**Stannah Lifts Technical Bulletin - Safety**

**Issue No: M4**

**Date: 12.10.98**

**LIFT TYPE:- STANNAH HOMELIFT (SHL)**

DRG TITLE: HOMELIFT POSITION SAFETY AWARENESS DRG

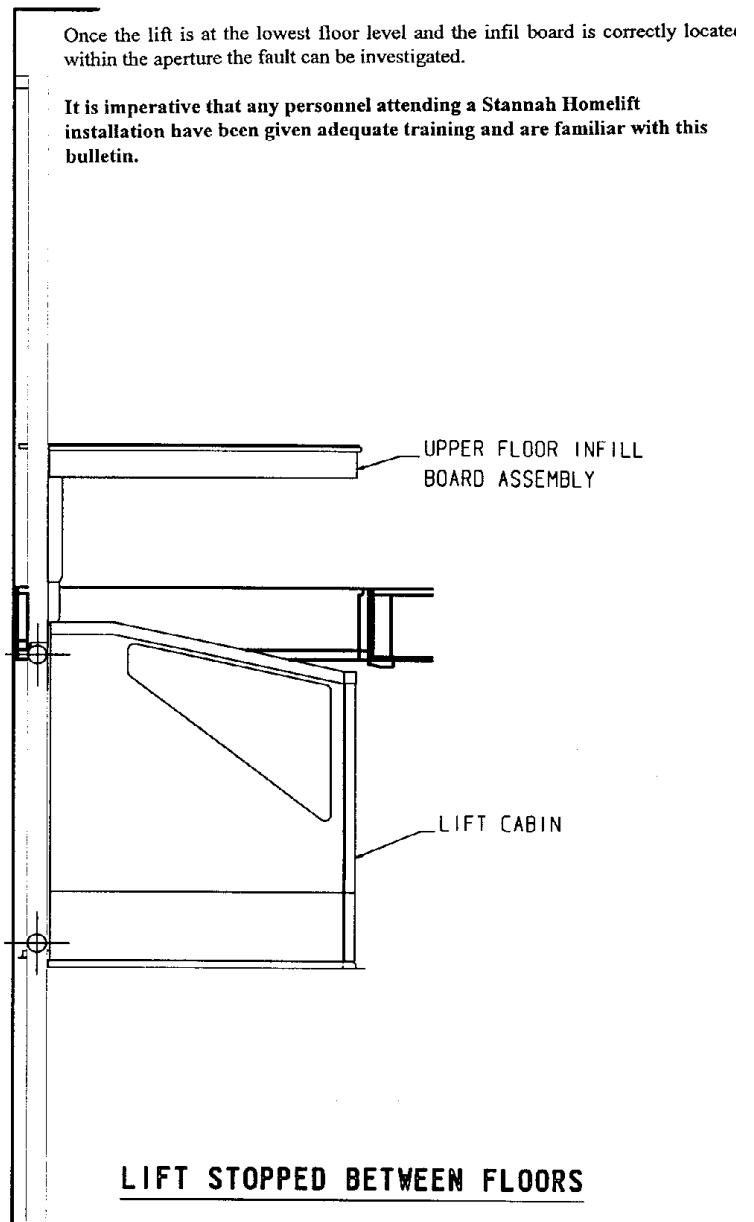
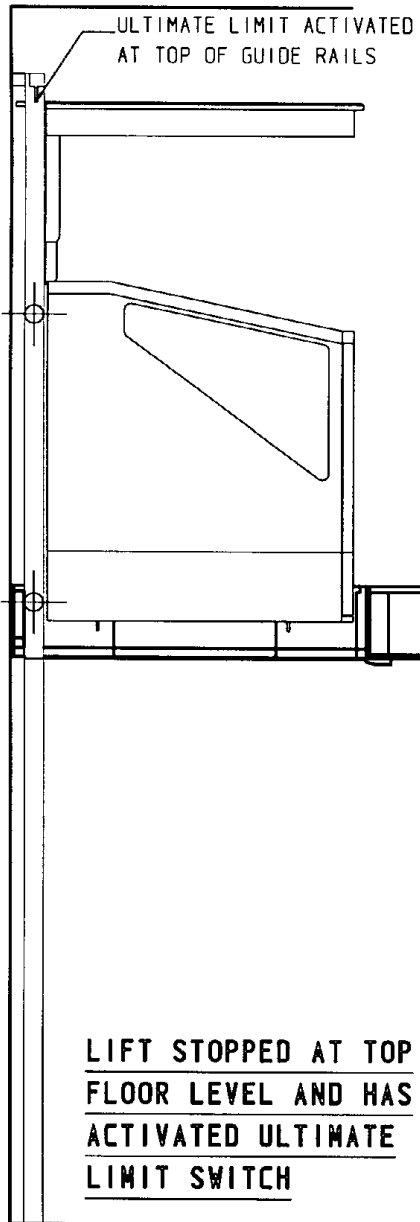
Site personnel should exercise extreme caution if a Stannah Homelift is found to be stopped between floors or has activated the ultimate limit switch as shown on the attached drawing, HD 3023.

Site personnel should exercise extreme caution if a Stannah Homelift is found to be stopped between floors or has activated the ultimate limit switch as shown,

We strongly recommend that the lift is **manually** lowered to the bottom floor level, in accordance with the emergency lowering procedures, prior to investigating any fault or attempting to operate the lift. It is particularly important that the aperture infill board assembly and concertina covers at the rear of the lift are not touched until the lift has been lowered to the bottom floor level.

We strongly recommend that the lift is **manually** lowered to the bottom floor level, in accordance with the emergency lowering procedures, prior to investigating any fault or attempting to operate the lift. It is particularly important that the aperture infill board assembly and concertina covers at the rear of the lift are not touched until the lift has been lowered to the bottom floor level.

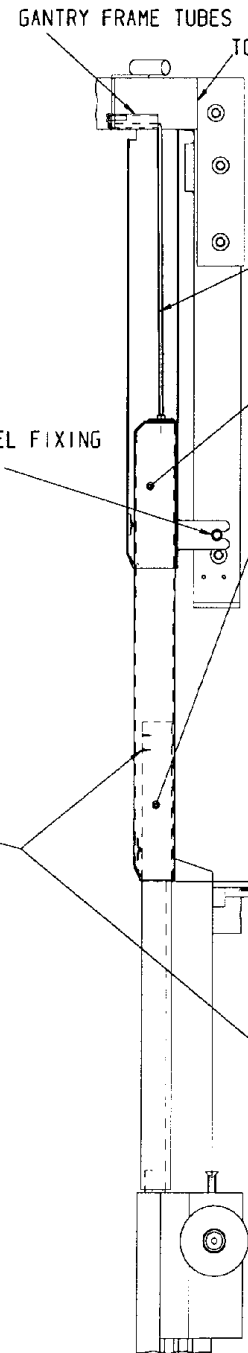
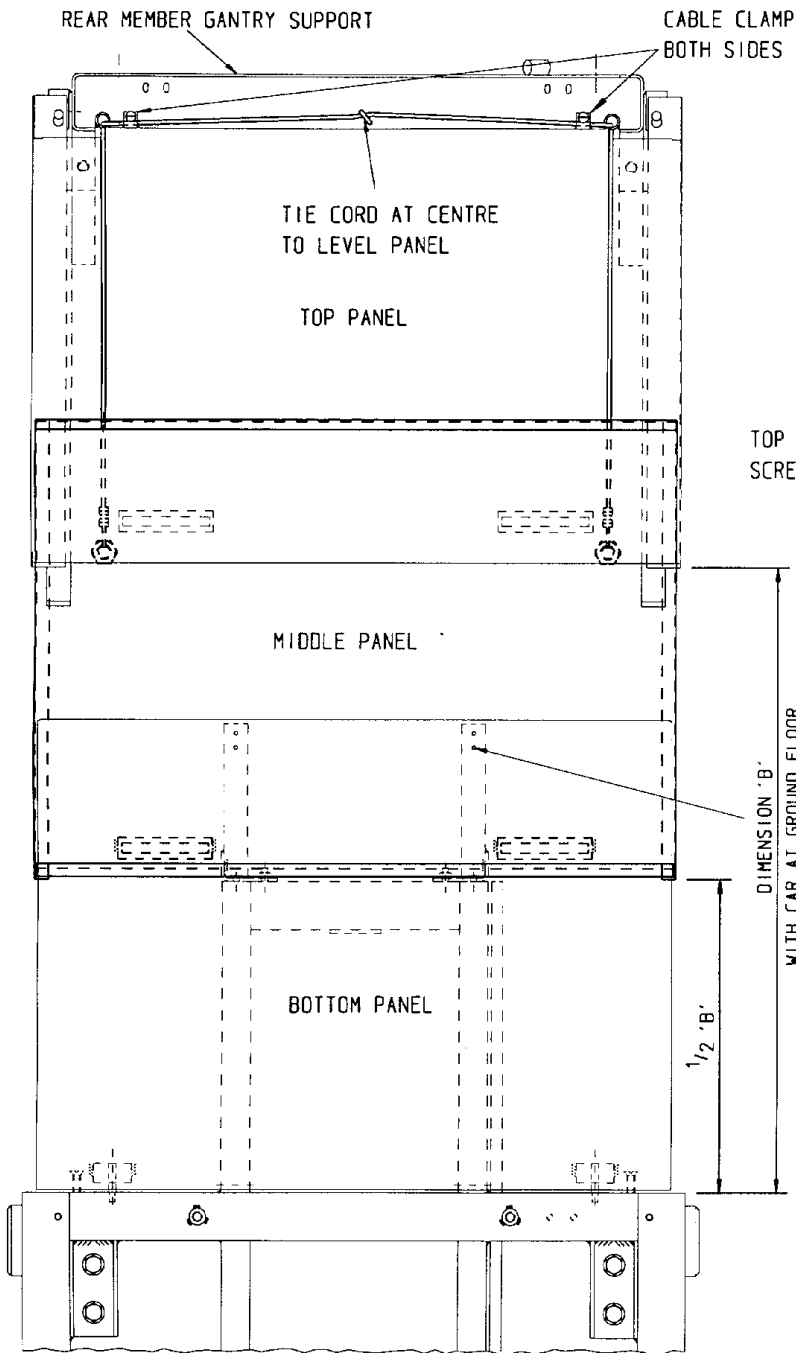
**HD 3024 Sliding Ram Cover.**

- This retrofit will replace the existing nylon cord to the outer ram cover with new 2mm wire rope and more secure terminations. A physical stop will also be fitted at the base of the hydraulic ram to protect the hydraulic coupling from any shearing hazard.

REMOVE EXISTING NYLON BRAIDED CORD  
THIS WILL BE LOCATED AT THE TOP  
OF THE RAM COVER

SOLDERLESS NIPPLE WITH KNUCKLE SCREWS  
FOR ADJUSTMENT. TRIM EXCESS ROPE  
ENSURING WIRE ROPE IS LOOPED BACK  
INTO NIPPLE.

FEED WIRE ROPE THROUGH EXISTING HOLES  
IN RAM HEAD ASSY AND OUTER RAM COVER  
ENSURE WIRE ROPE DOES NOT INTERFERE  
WITH MOVEMENT OF RAM

REMOVE EXISTING SCREWS IN BASE OF FIXED RAM COVER  
FIT NEW 'U' SHAPED BRACKET WITH No. 6 x 5/8"  
SCREWS SUPPLIED

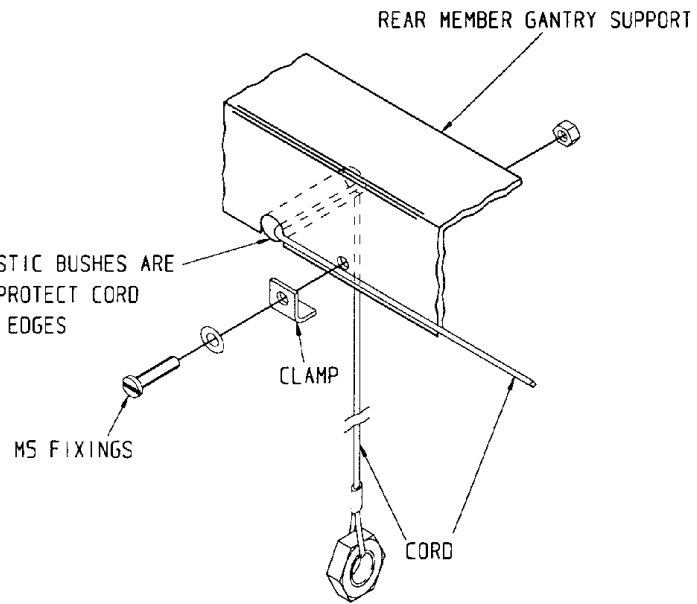
**HD 3025(A) Middle Concertina Cover at the Rear of the Lift.**

- The cord supporting the middle concertina panel will be replaced with new nylon cord to ensure that the correct specification has been used and that the cord is free from wear and abrasion.

- The cord will be clamped on both sides where it is attached to the overhead infill board assembly. This means that the cord would have to break in 2 places for the cover to drop down.
- The nylon cords supporting the middle concertina panel are to be terminated with a more secure crimped ferrule to replace the knotted termination.

ENSURE THERE IS A ADEQUATE OVERLAP WITHIN THE PANELS TO PREVENT ANY EDGES CATCHING WITH NORMAL MOVEMENT

ENSURE PLASTIC BUSHES ARE FITTED TO PROTECT CORD FROM SHARP EDGES

NOTE: ENSURE FIXING HOLES IN BOTTOM PANEL ARE COUNTERSUNK AND SCREW HEADS ARE FLUSH

- Check the cords supporting the middle concertina cover and the ram cover for signs of wear, abrasion failure of terminations, or any other abnormalities.
- Check that the countersunk screws used to retain the bottom concertina cover are flush and not protruding. (See HD 3025A).
- Ensure that there is adequate overlap of the concertina panels. (See HD 3025A).
